STANDARD DEPARTURE CHART -INSTRUMENT

RJOE / AKENO

KOWA SEVEN DEPARTURE

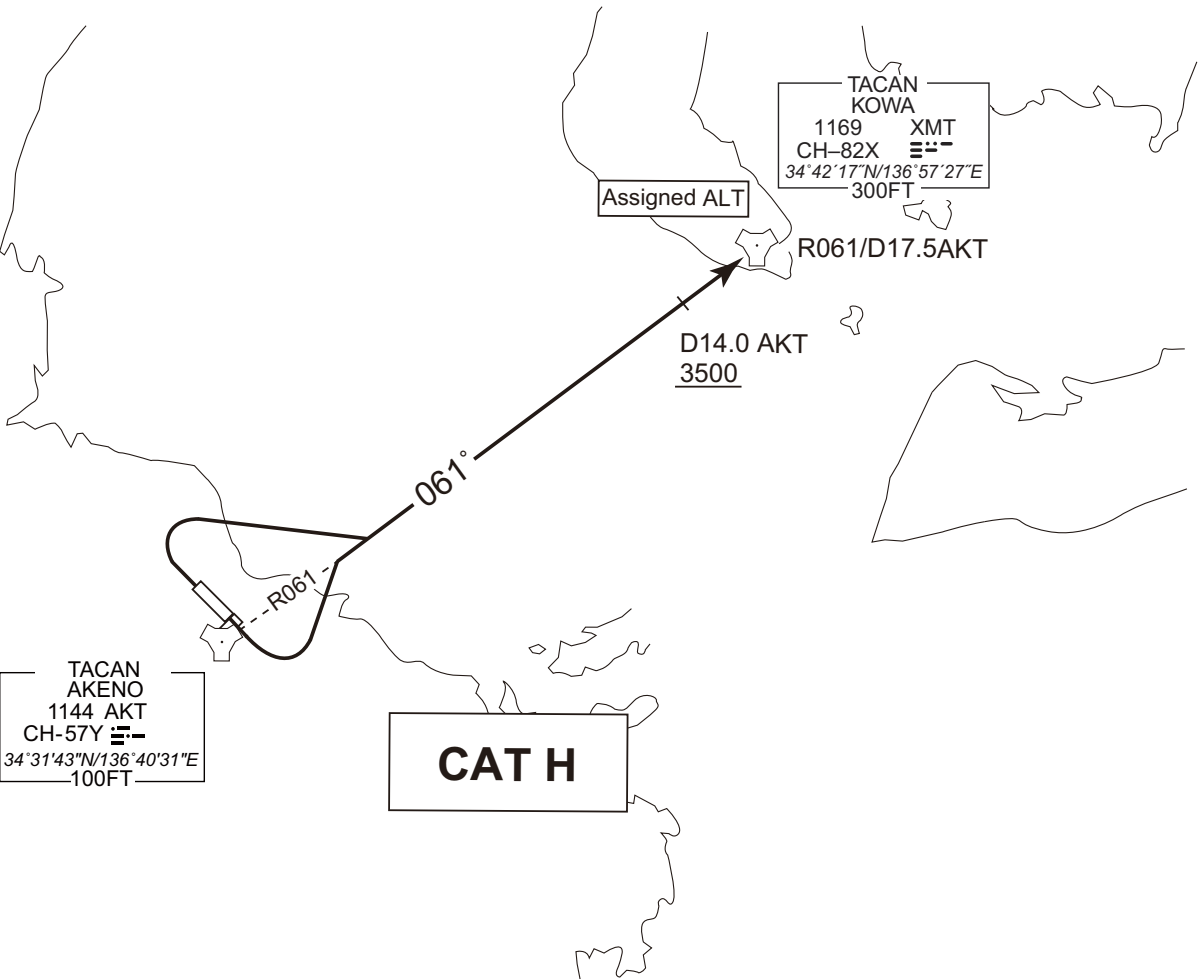
CHANGE : PROC course. PROC renamed(KOWA SEVEN DEPARTURE). NOTE added. ASAMA ONE DEPARTURE abolished.

...to intercept and proceed via AKT R061 to XMT TACAN.

Cross AKT R061/14.0DME at or above 3500FT, cross XMT TACAN at assigned altitude.

Note RWY13/31 : No turn before DER.

HISAI TWO DEPARTURE

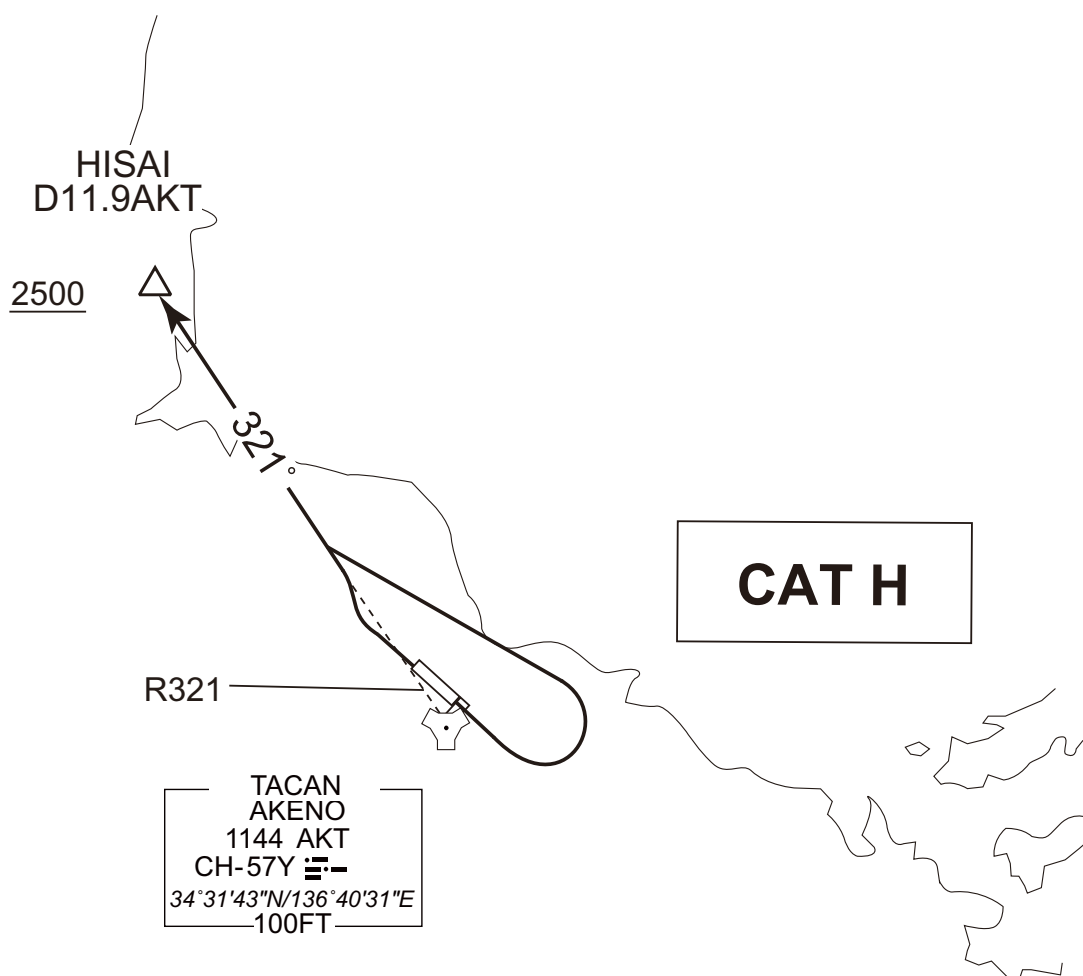
CHANGE : PROC course. PROC renamed(HISAI TWO DEPARTURE). NOTE.

...to intercept and proceed via AKT R321 to HISAI.

Cross HISAI at or above 2500FT.

Note RWY13 : No turn before DER.

5.4% climb gradient required up to 400FT.

OBST ALT 159 FT located at 0.4NM 173° FM end of RWY13.

Note RWY31 : No turn before DER.

TACAN RWY13

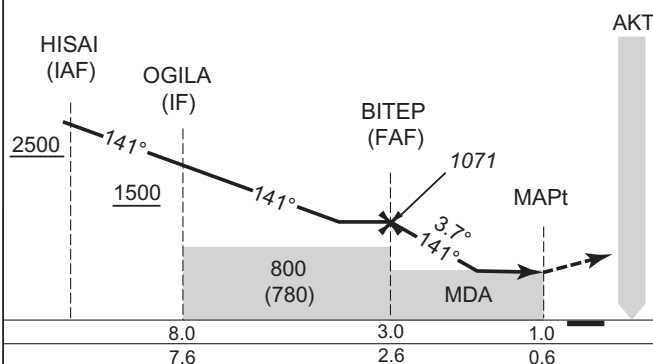
CHANGE : PROC course, PROC renamed. Missed APCH PROC. MINIMA. ALT(3.7°APCH Path) established. HLDG Pattern. DME to AKT,NM to THR established. OGILA BITEP established. MSA. VAR.

Turn left, climb to 2500FT
via AKT R321 to HISAI and hold.

Timing not authorized for defining the MAPt.

MINIMA		THR elev. 18	AD elev. 20	
CAT			CIRCLING	
	MDA(H)	CMV	MDA(H)	VIS
H	400 (380)	1500	530 (510)	1600

Circling to RWY31 ONLY.
